**RE: Proposed Subdivision Frankton Rd RM980009**

**PROPOSED SUBDIVISION, FRANKTON RD  
REF. RM980009**

**GEOTECHNICAL REVIEW**

FIGURE  
1

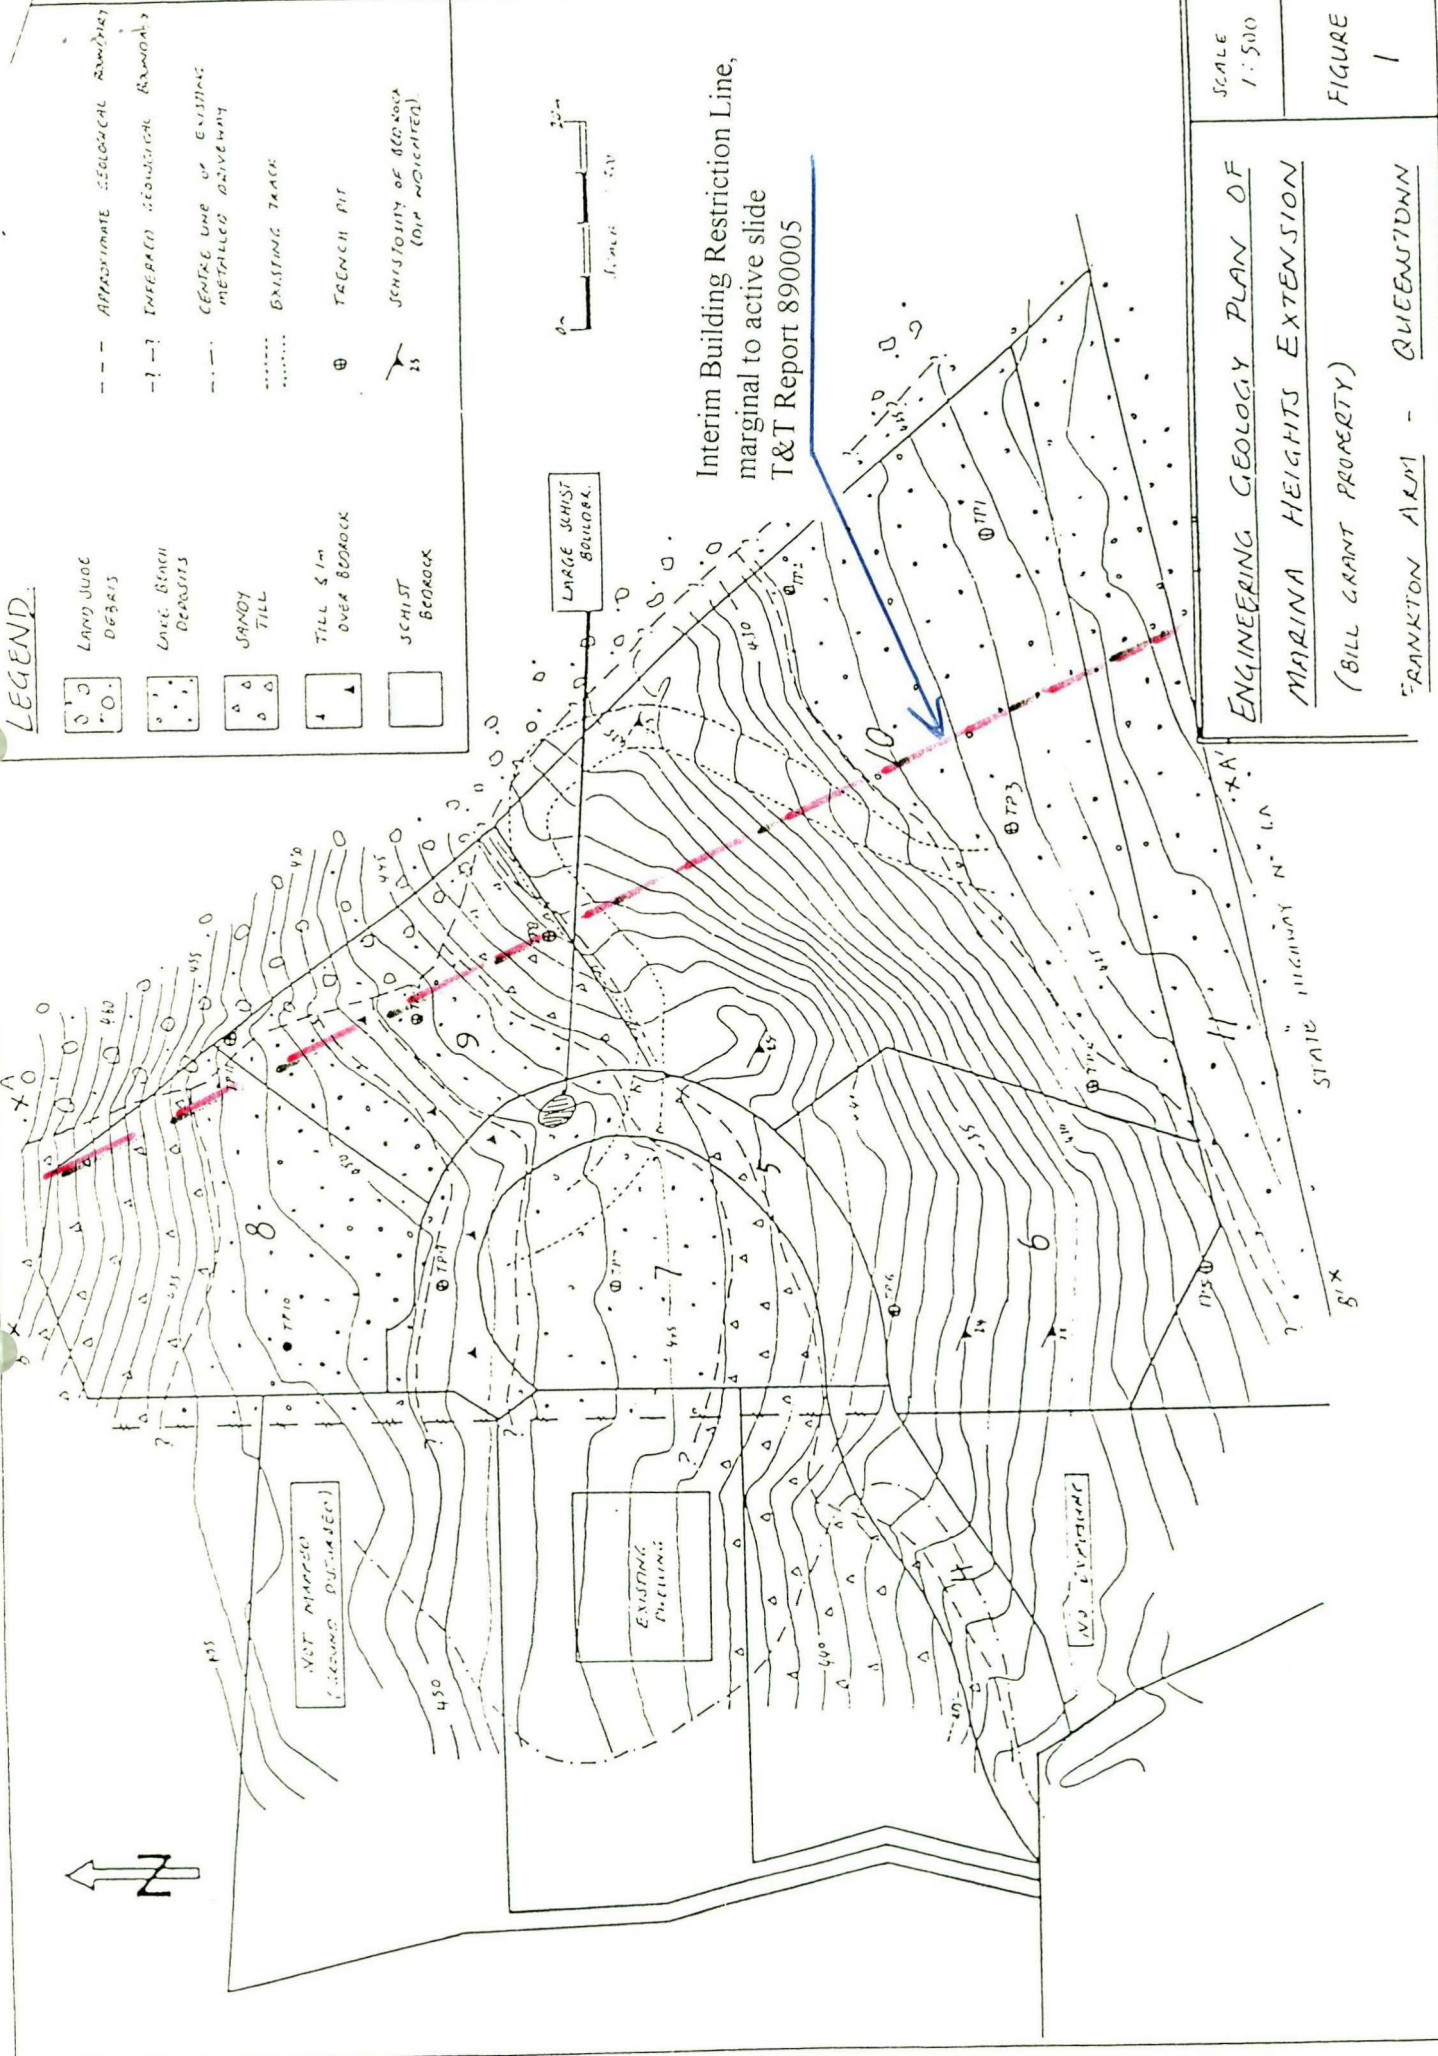
Site investigation and geological mapping of the site itself are appropriately addressed in the Canterprise report. However, a principal issue is the location of a large schist debris landslide which crosses the north eastern boundary of Lots 8 and 9. Only a small portion of each lot is affected. Mapping of the full landslide is not included with documentation supplied.

The common mode of failure of large schist slides in Otago is one of continuing gradual creep at rates of several millimetres per year (depending on relative rainfall), rather than “single movement” events. For this reason, and as there is no evidence to the contrary we would expect this slide to be classed as active.

As a result of our investigations comprising site inspection in March 1998, examination of stereoscopic aerial photographs, comparison with other schist derived slides with accurate survey monitoring, and discussions with colleagues (both internal and external to Tonkin & Taylor), we conclude that this is an active landslide, which will be creeping at variable rates - probably reaching about 30 mm/year.

In our opinion, the active slide requires a marginal strip for future downslope movement, so that any dwellings constructed have a distinct clearance from the slide. Our assessment of such a building restriction line (from our inspection and the information presently available) is shown on Figure 1. We appreciate that at the building consent stage, this boundary could be modified as a result of more detailed site specific investigations or monitoring.

Interim Building Restriction Line,  
marginal to active slide  
T&T Report 890005

1. Adopt a building restriction line. The subdivision is bordered and locally intruded by a large active landslide which will be creeping, probably at rate of about 30 mm/year. We suggest that the active slide requires a margin for future downslope movement, so that any dwellings constructed have a distinct clearance from the slide. Our assessment of such a building restriction line is shown on Figure 1. An advantage of such a restriction is that potential purchasers can be made aware of the adjoining hazard. At the building consent stage, this boundary may be modified as a result of more detailed site specific investigations or monitoring.
